**GENOA CHARTER TOWNSHIP
PLANNING COMMISSION PUBLIC HEARING
MONDAY, MARCH 14, 2016
6:30 P.M.
AGENDA**

Attention:	Kelly Van Marter, AICP Assistant Township Manager and Planning Director
Subject:	CRW Plastics outdoor storage – Special Land Use and Sketch Plan Review #2
Location:	5775 Brighton Pines Court – west of Dorr Road, between Grand River and I-96
Zoning:	IND Industrial District

Attention:	Kelly Van Marter, AICP Assistant Township Manager and Planning Director
Subject:	Proposed rezoning from MDR to HDR – Review #2
Location:	Chilson Road – east side of Chilson, between Grand River and C&O Railroad
Zoning:	Medium Density Residential District

PROPOSED SITE PLAN
LOT #4 BRIGHTON PINES CT.

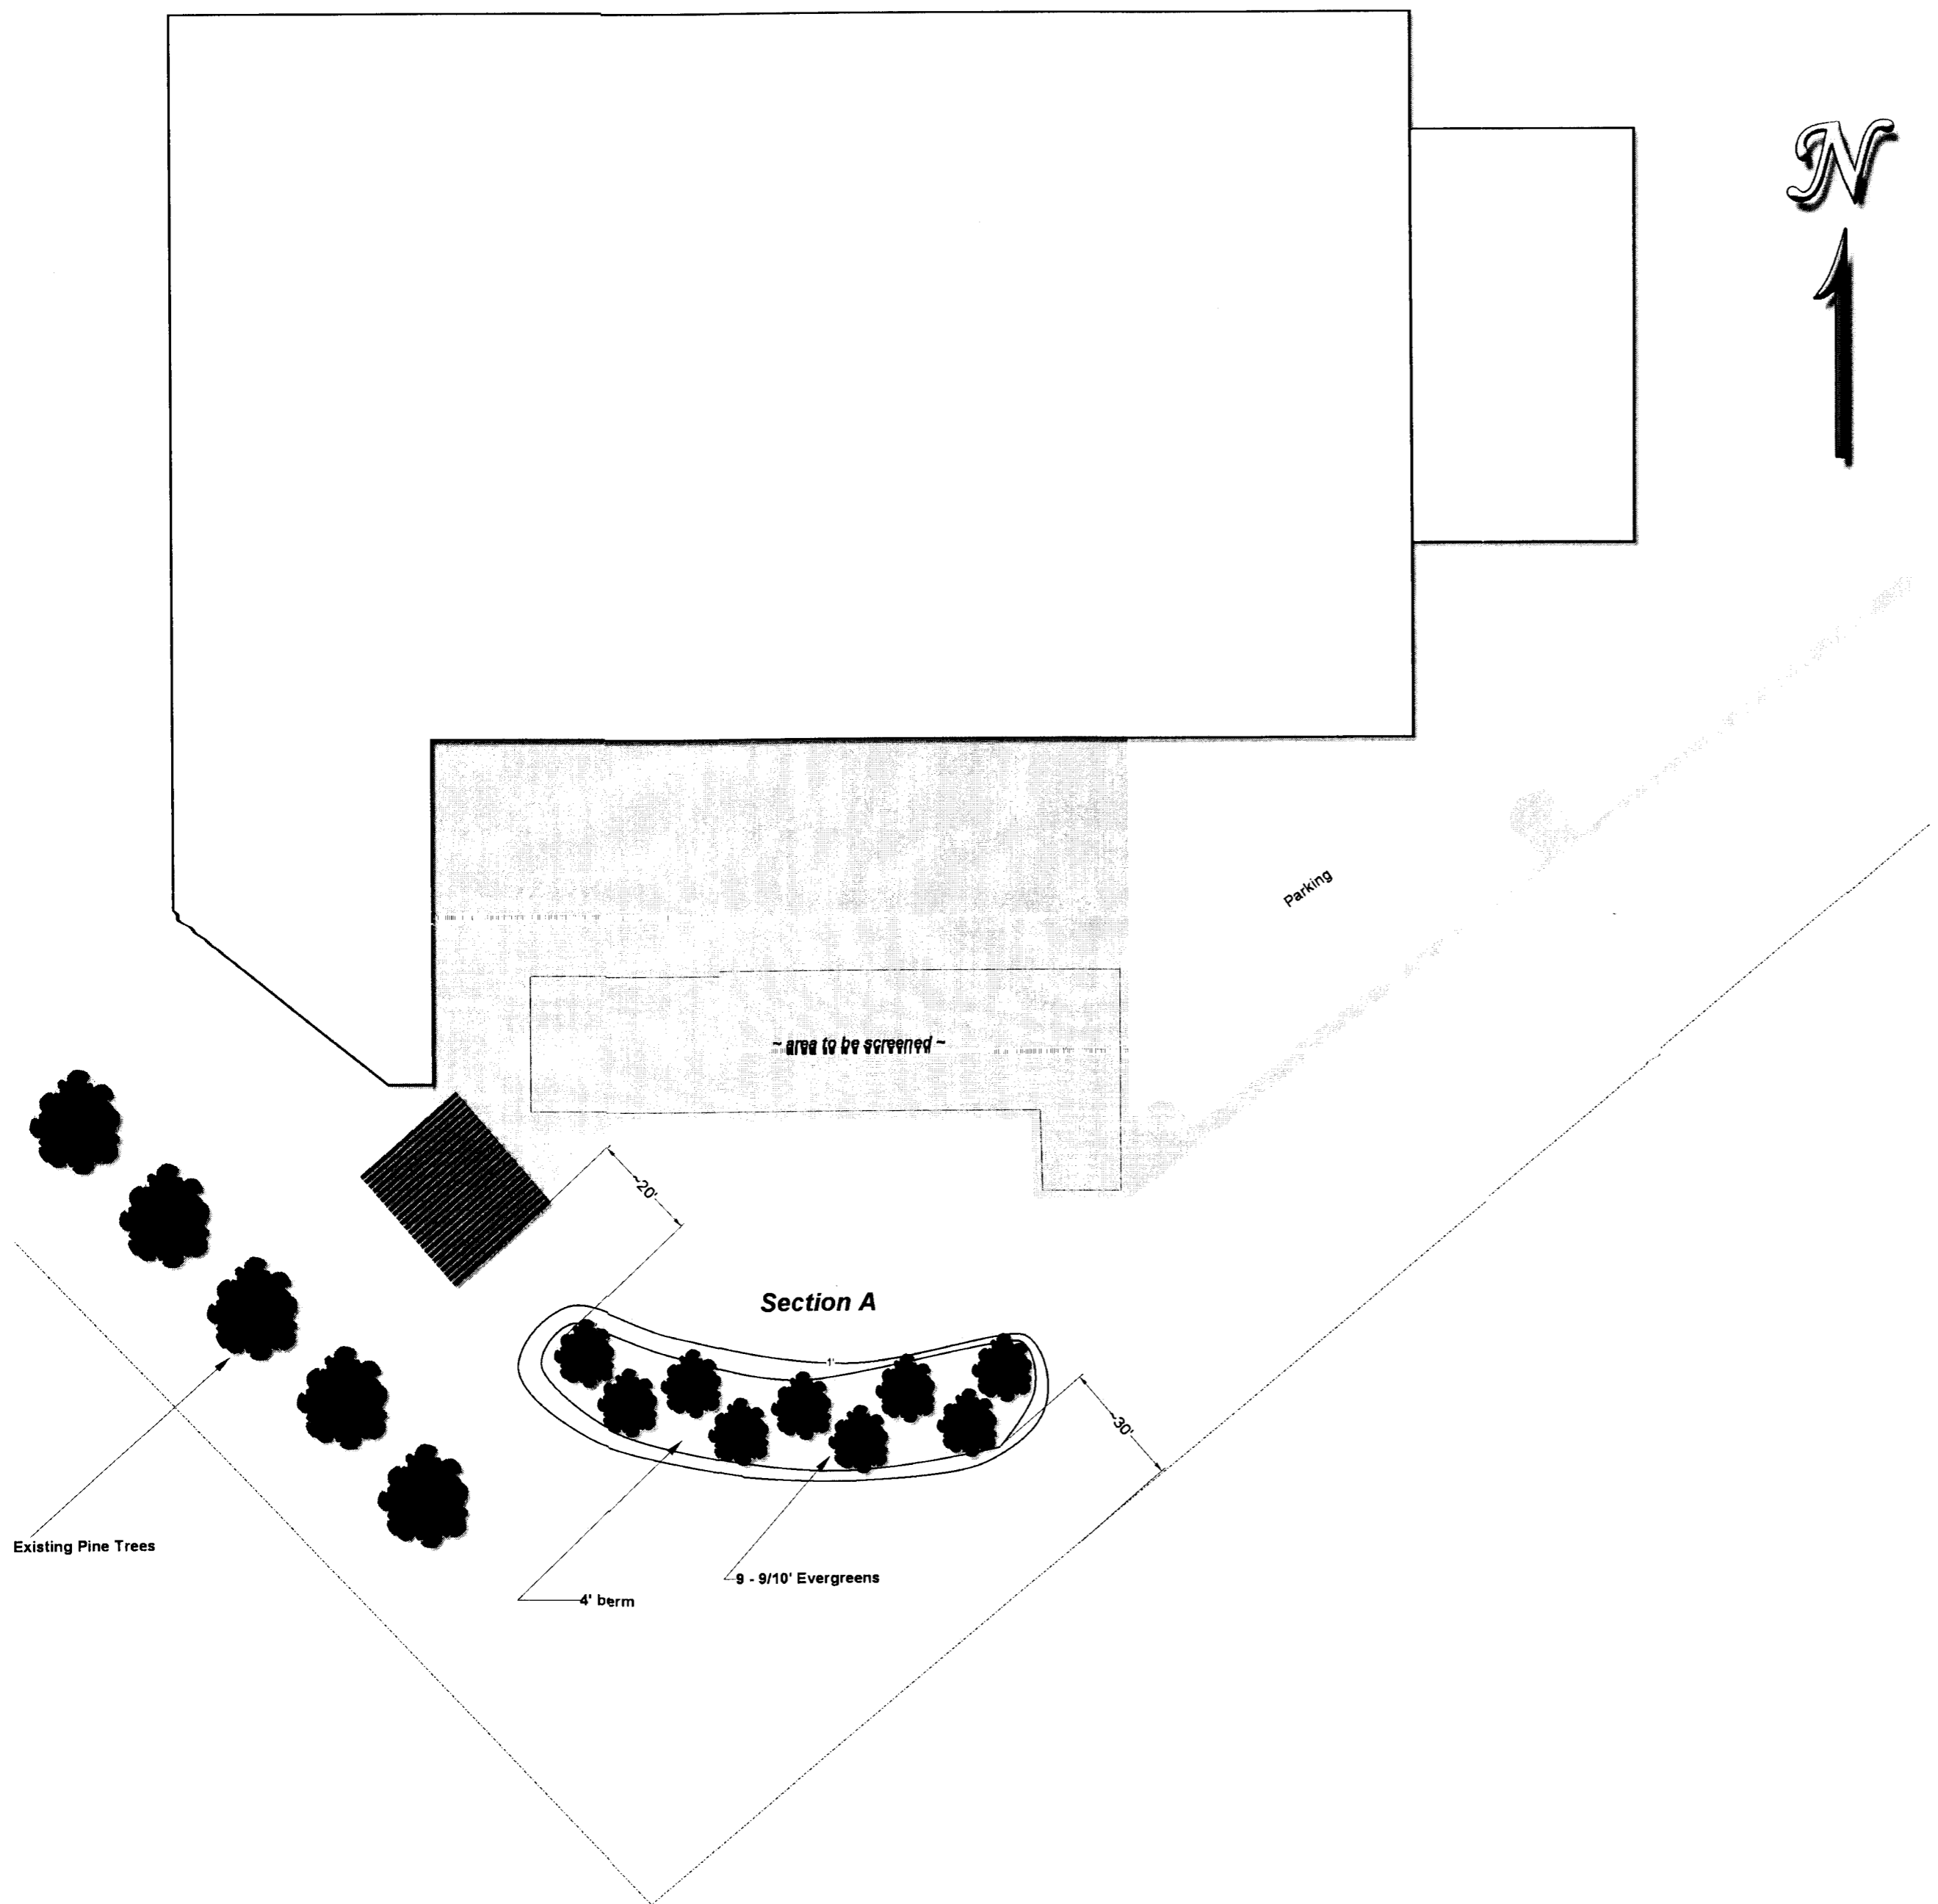
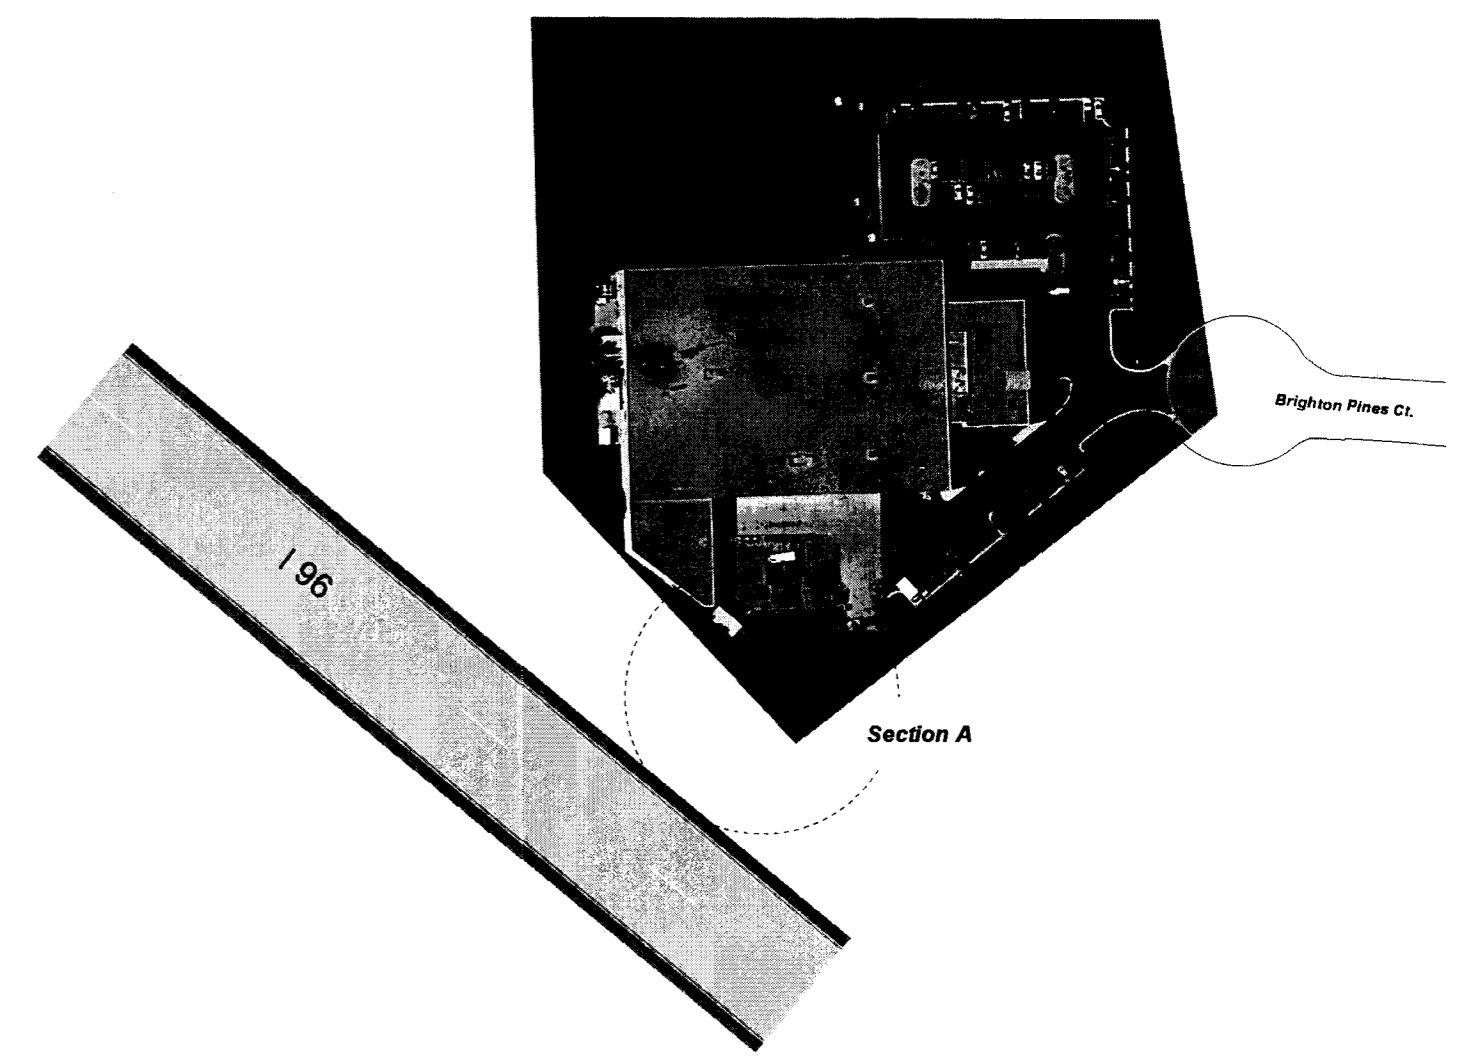
As requested, we have reviewed the revised sketch plan (stamped received on 2/24/16) which proposes an outdoor storage area in the southerly side yard of the developed site at 5775 Brighton Pines Court.

The request was originally presented to the Commission at their February 8th meeting. Discussion at that time revolved around the need for additional screening. In response, the applicant has submitted a revised plan showing a 4-foot tall berm with 9 evergreen trees on the south side of the outdoor storage yard.

Section 8.03 requires setbacks of 40 feet (rear) and 25 feet (side). While the exact setback provided is not shown on the plan, the storage area is clearly outside of the minimum setback requirements for the IND. This standard is met.

The revised proposal demonstrates compliance with the depth requirements of a buffer zone B along the rear (SW) and side (SE) lot lines. Additionally, the new plan now provides for 9 new evergreens that are 10' tall and will be planted on a 4' berm.

The Impact Assessment notes a requested storage height of 12 feet; and the proposed screening will now provide a noticeable screening benefit to the site.

7 SLAB DETAIL
A-22 SCALE: 1" = 1'-0"

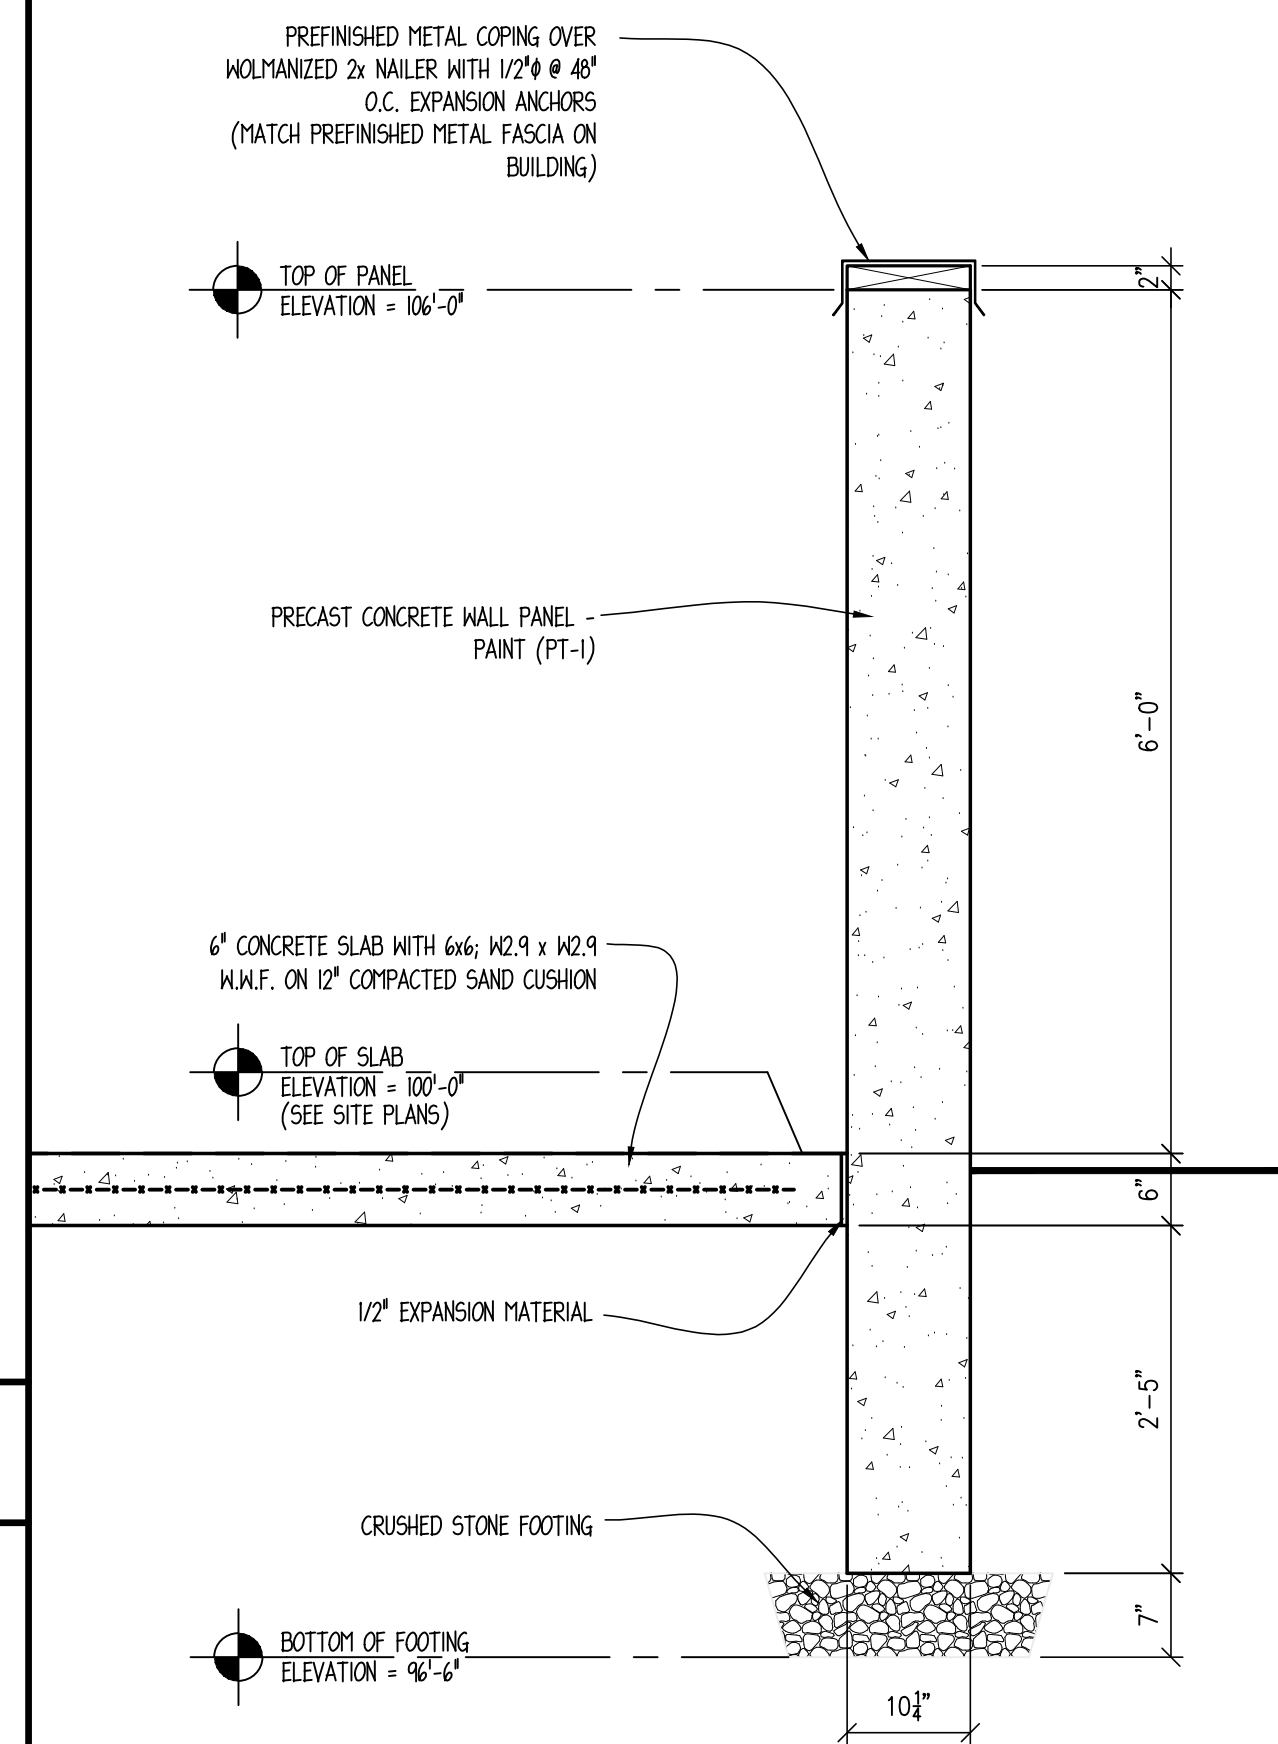
Details on Sheet A-22 identify a concrete base pad and a painted concrete enclosure, which is to match materials used on the building. Our only comment is that the depth of the concrete base pad must be extended to support the weight of refuse removal vehicles.
